REVISED
P.O.A.D.P. for

BRAUN STATION

RE: Braun Station Subdivision POADP #260

RE: BRAUN STATION

1st

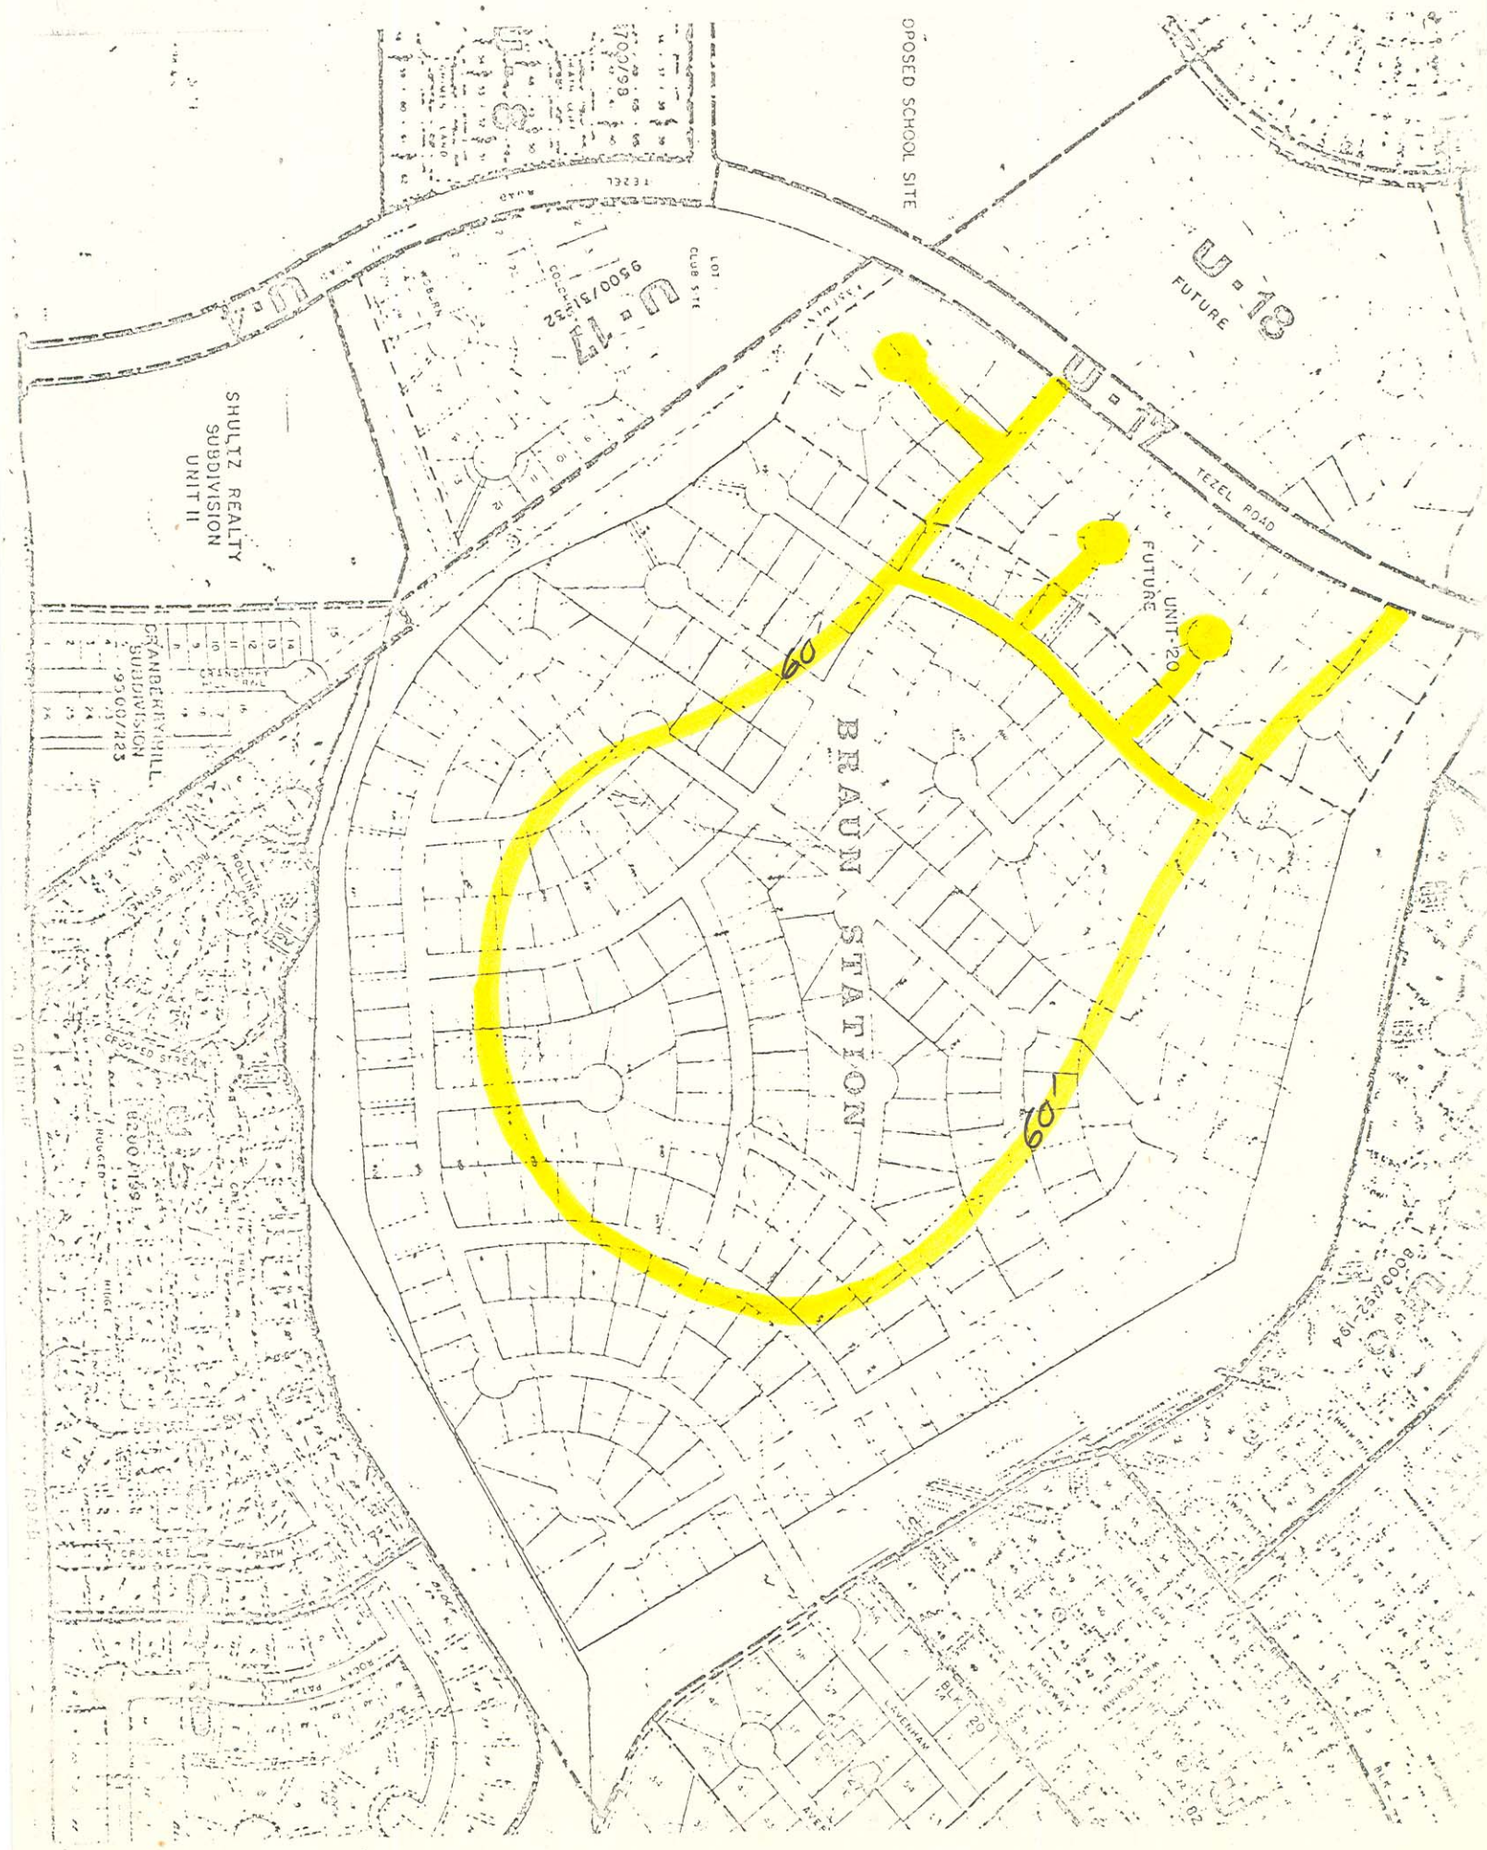
We recommend that you reconsider the number of planned access points onto Tezel Road. Your plan reflects five streets feeding into Tezel Road within a short span and four of those are cul-de-sac streets. We suggest that as a minimum the cul-de-sac streets be internalized to feed into the interior of the subdivision rather than directly onto Tezel Road. Secondly, a collector street system is recommended to carry all of the internal traffic onto Tezel Road at one or two points. We have attached some options which illustrate our comments and which you may wish to utilize during your review.

The first option provides for a loop collector 60' R.O.W. for internal circulation with two points of access. The second option shortens the loop 60' collectors and also provides dual access. The third option is in keeping with your proposed plan with the exception of the 60' collectors. The options are all focussed on minimizing the number of access points along Tezel Road and evenly disperse traffic feeding into and from Tezel Road. In addition, to internalize the cul-de-sac streets along Tezel Road. Also, all options would require a 1' vehicular non-access easement along Tezel Road to control access from the abutting lots. We believe that these alternatives are the best possible options to protect and promote the public health, safety and general welfare of the community. Staff further notes that Guilbeau and Braun Roads are designated as 86' facilities and Bandera Road as a 110' arterial on the Major Thoroughfare Plan.
